Revision Number 1

MO – Rt. 291 & 150 – REVISION 1

Documents for the referenced project are hereby being amended per this revision (Revision No. 1, per Building Permit Comments). Changes are noted in the text below. The summary of changes includes, but is not limited to the following:

2 NORTH ELEVATION
Scale: 1/4" = 1'-0"

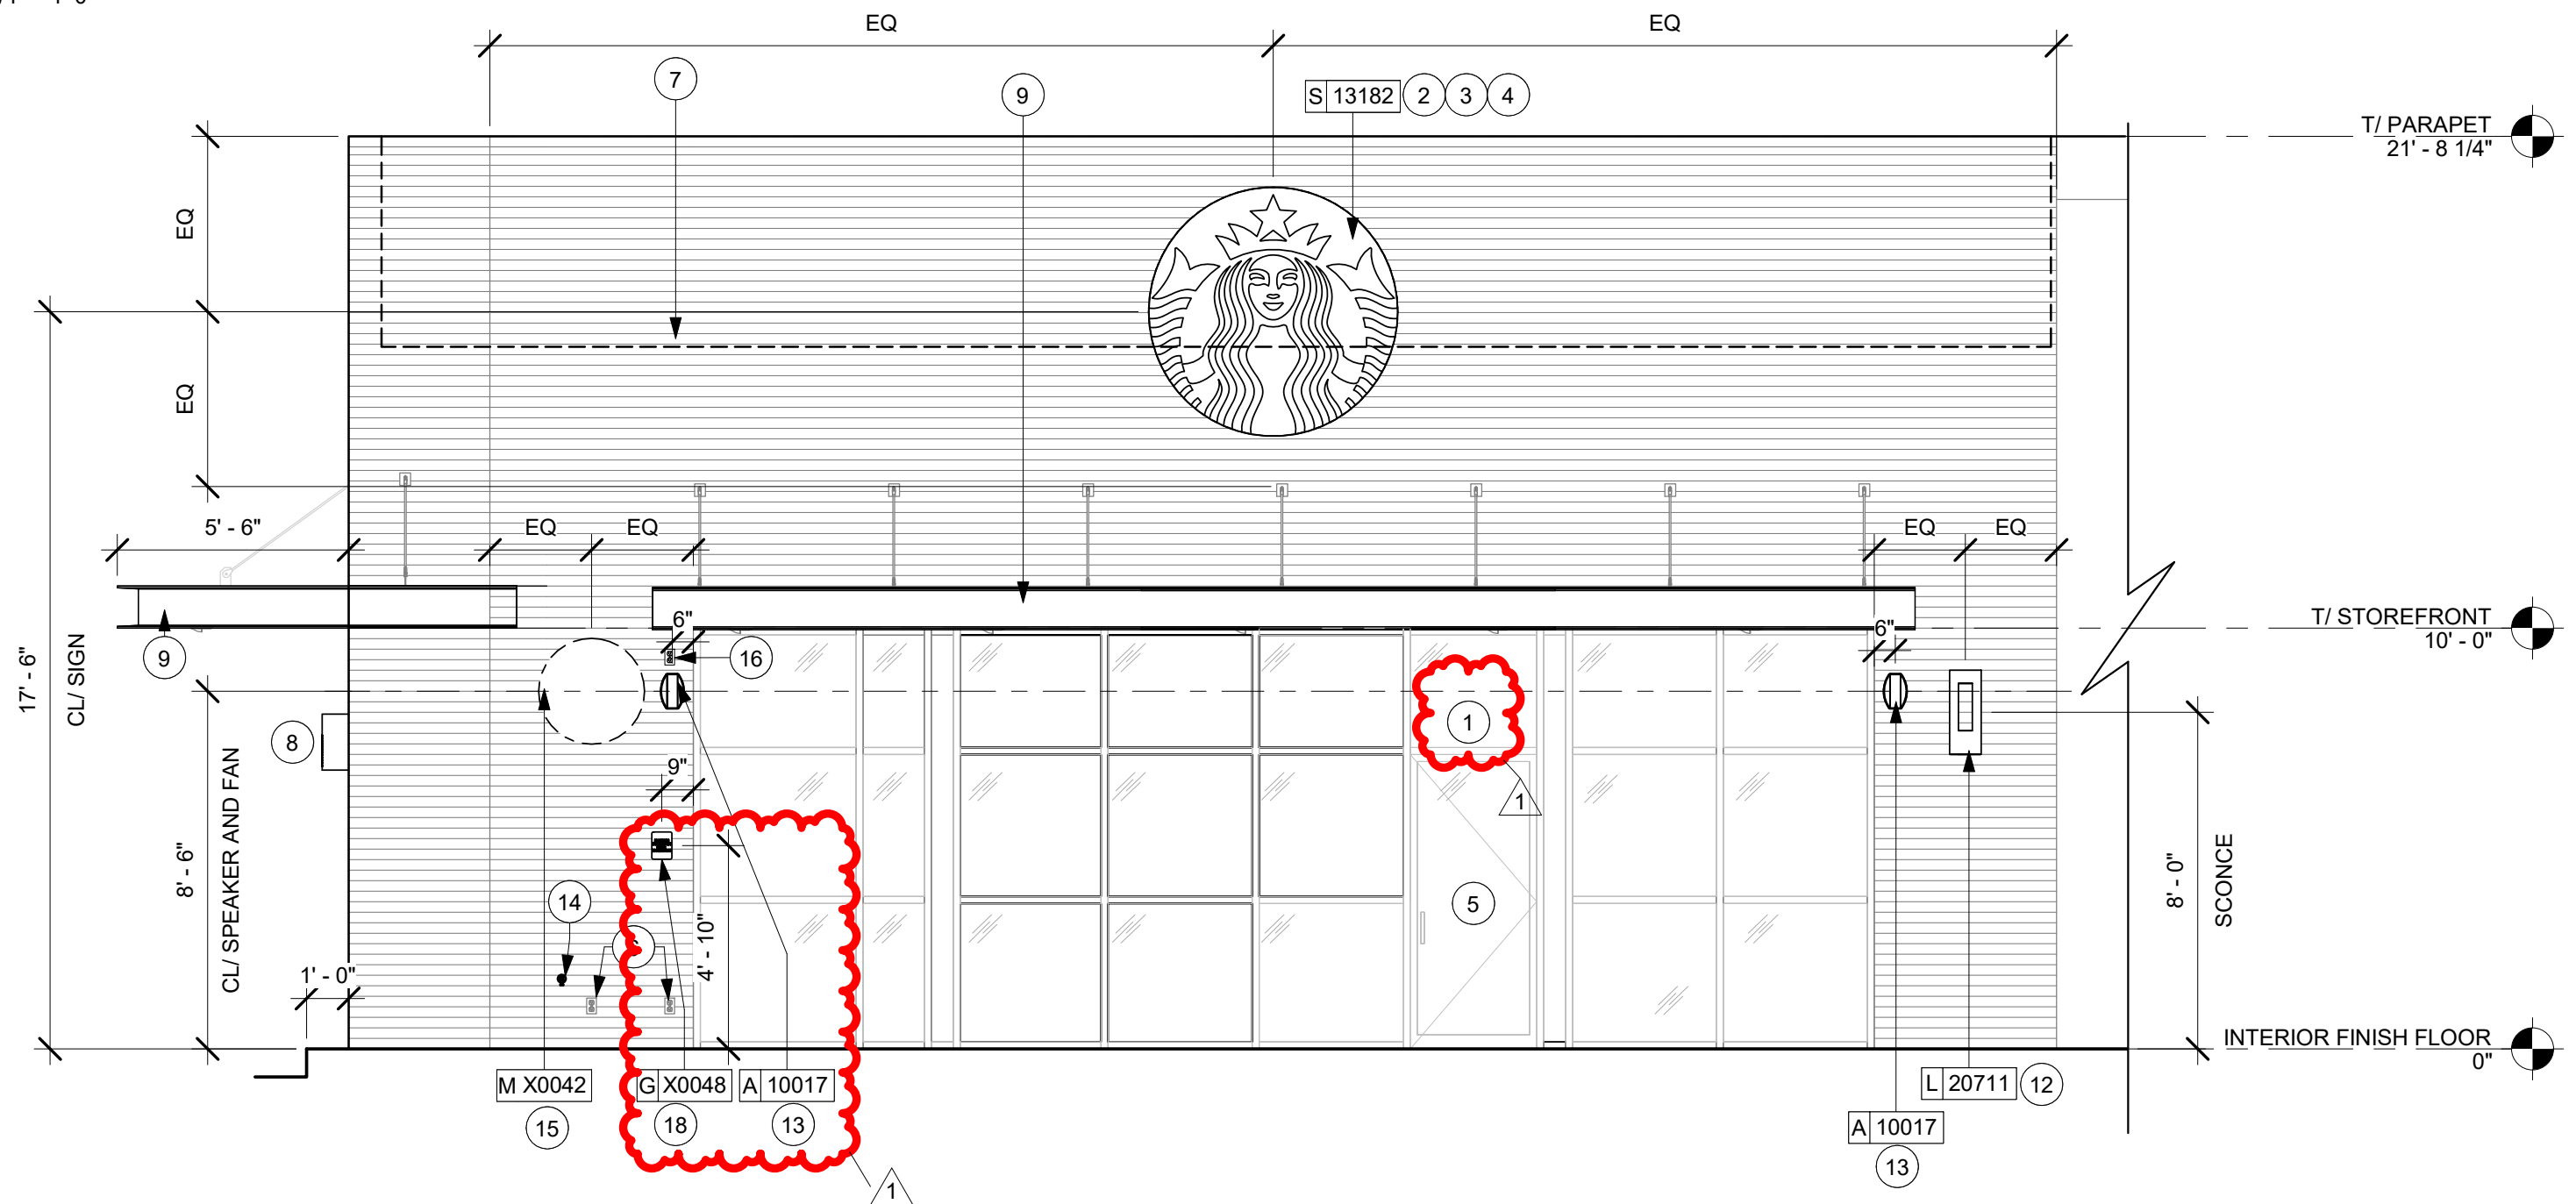
Added and tagged occupancy sign in elevation #2, per Fire Department Comments.

M101

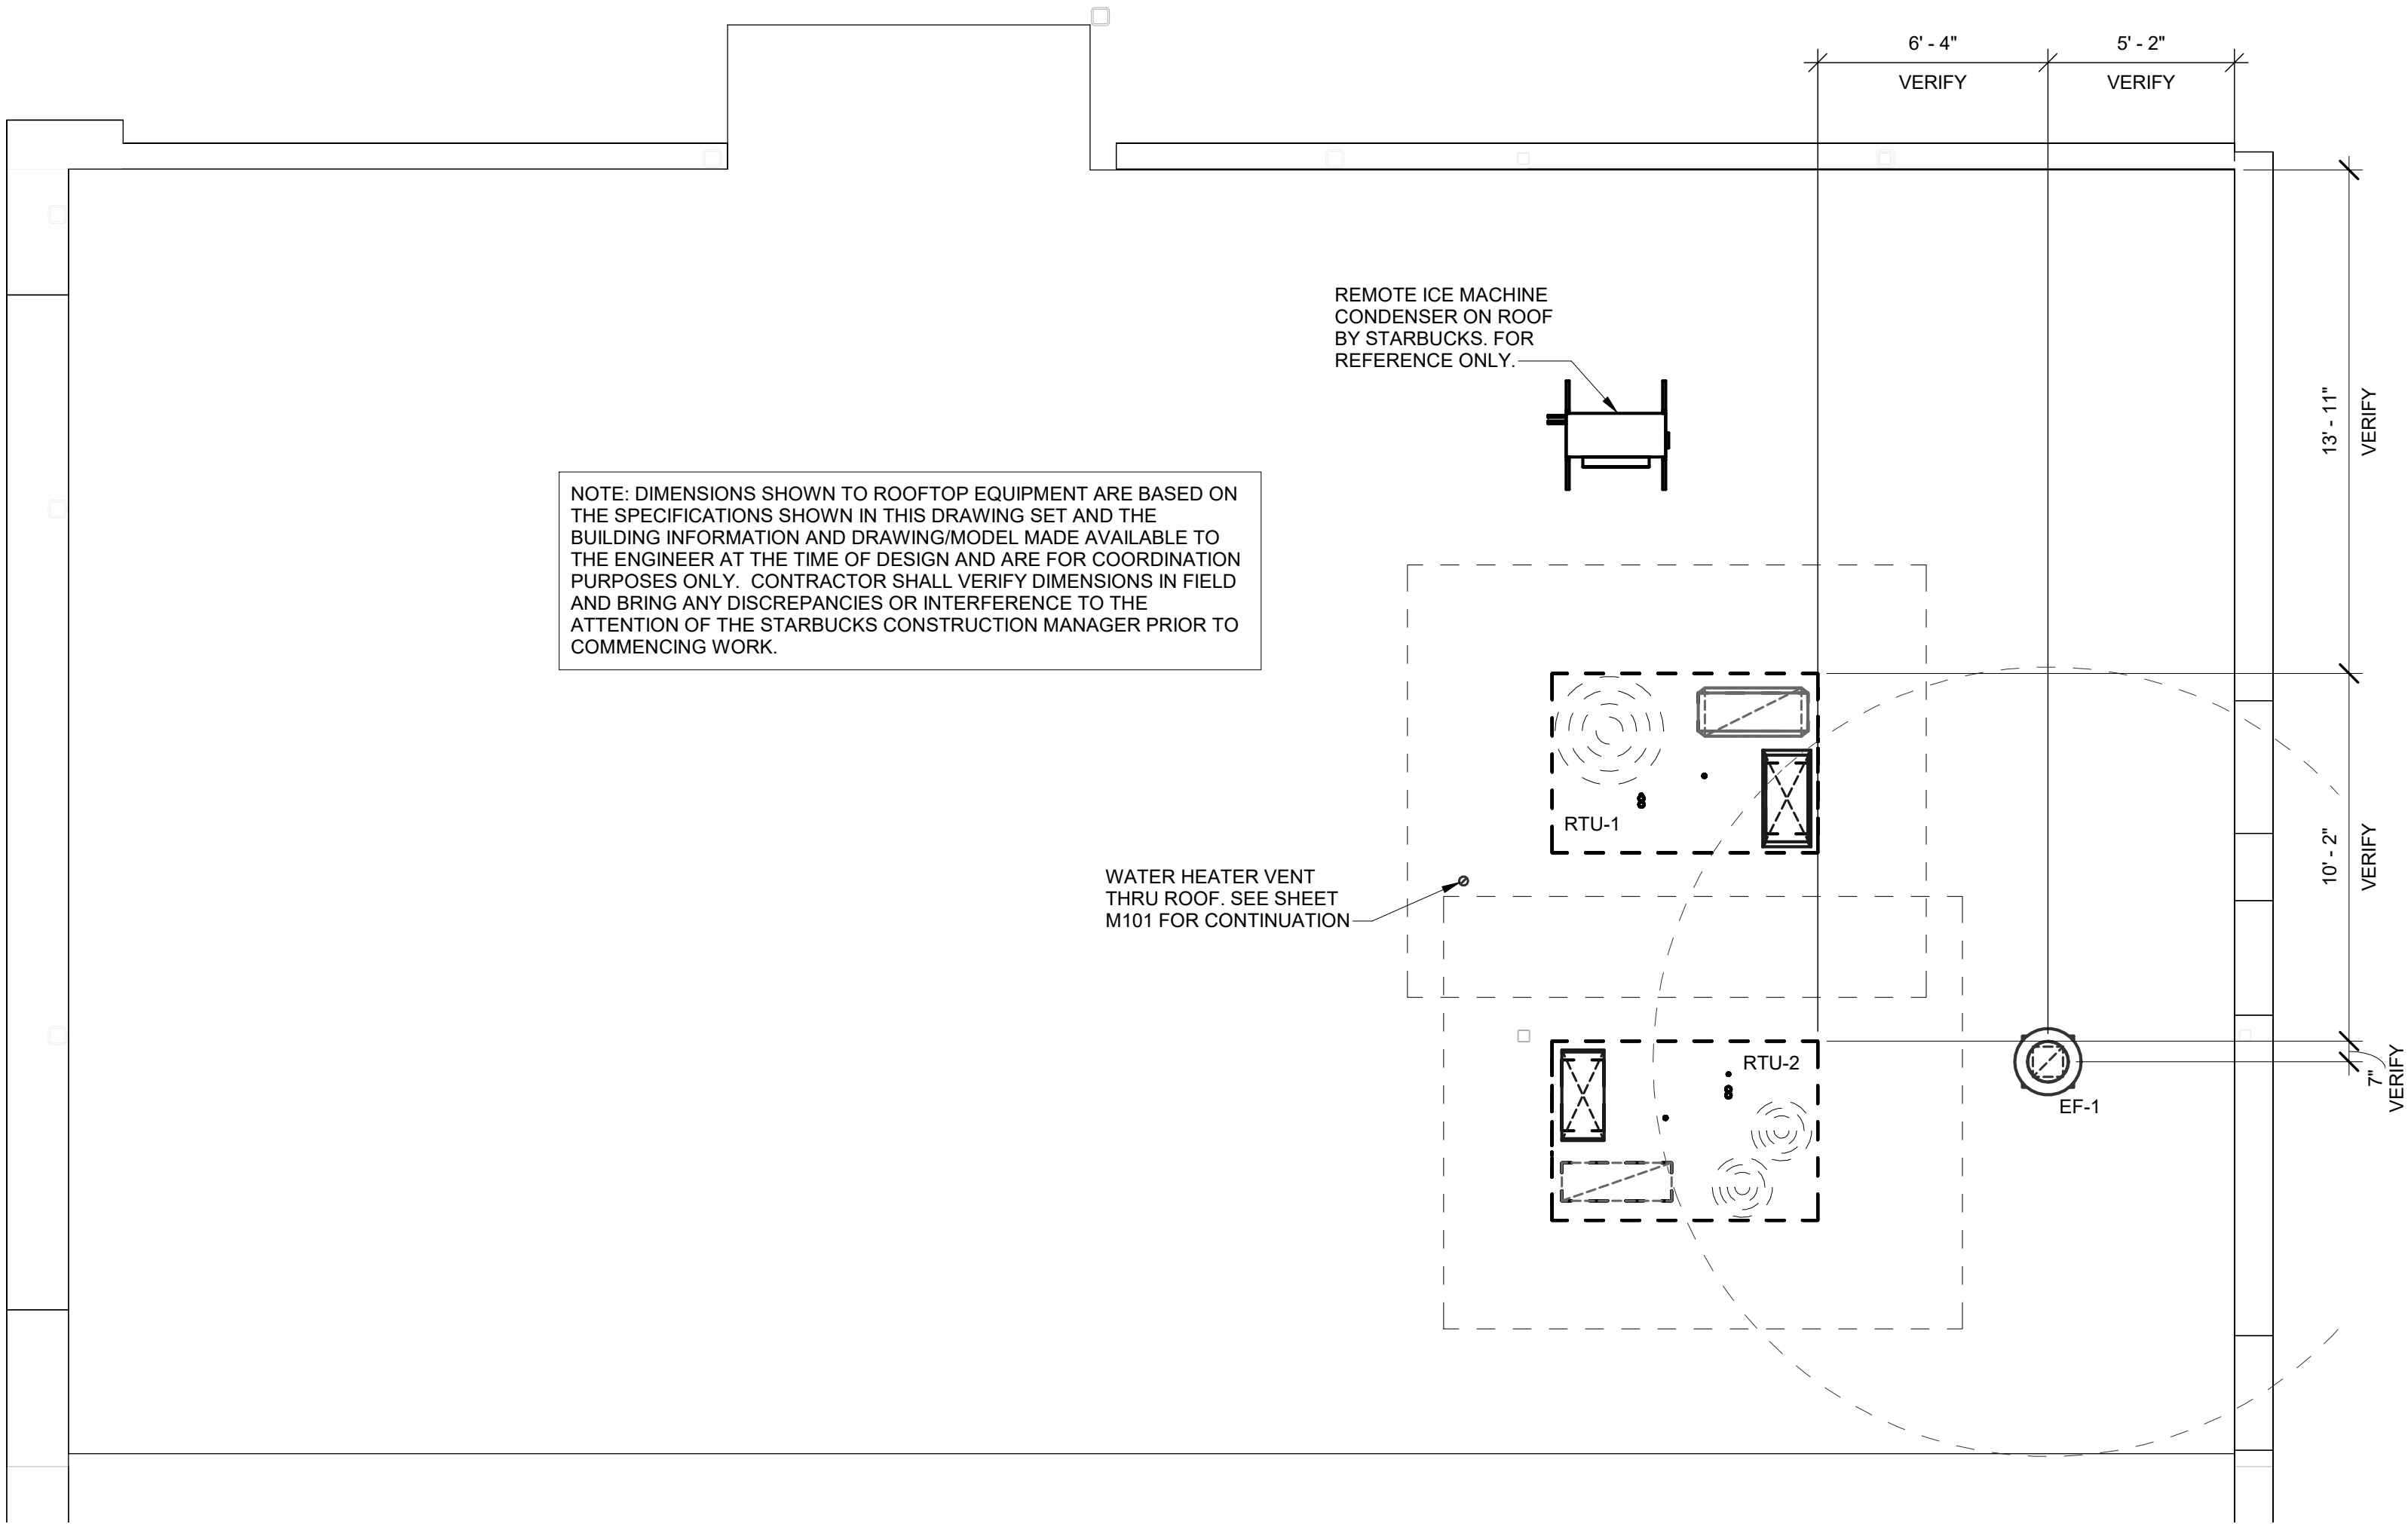
Sheet M101 plan was revised to show locations of remote test switches for each RTU labeled as "A/V" on the plan. Keyed note 1 was revised to designate this.
